## Video Products Technical Bulletin 30-2003-150

DATE: **August 11, 2003**SUBJECT: **REUSE IC101 WHEN REPLACING THE A BOARD**

MODEL: **OEV202**  
**OEV202**  
**PVM-1953MD**  
**PVM-1953ST**  
**PVM-2053MD**

**Figure 1**

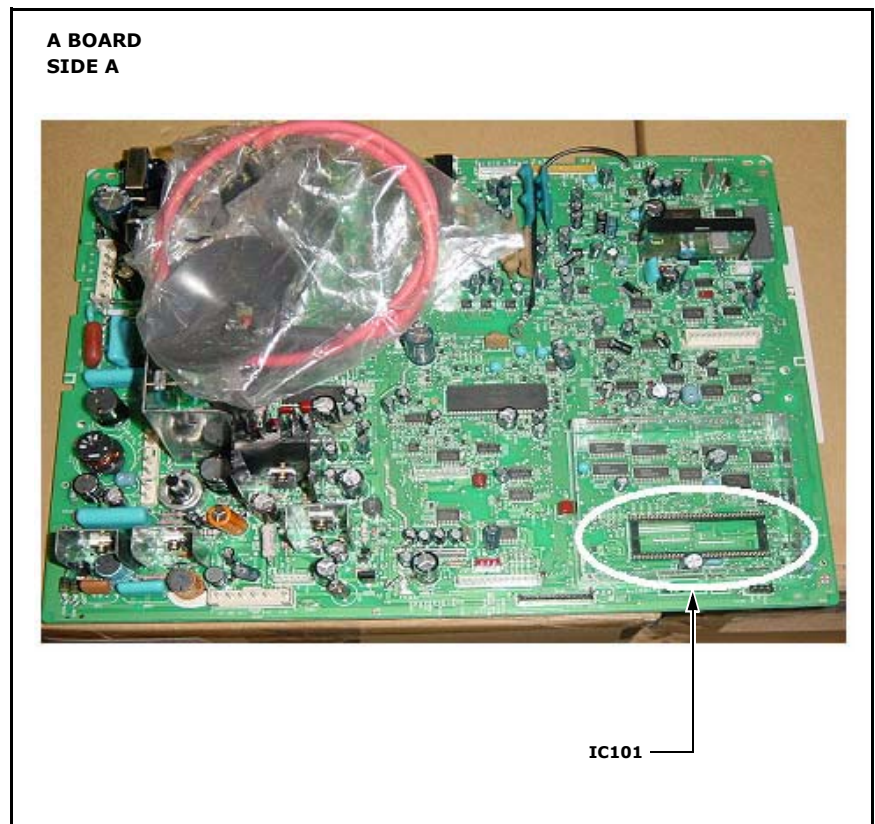
The new A board does not contain IC101, and IC101 is no longer available as a service part. (See Figure 1.)

When replacing the A board (A-1297-470-A), remove IC101 (8-759-399-23) from the former board and install it on the new board.
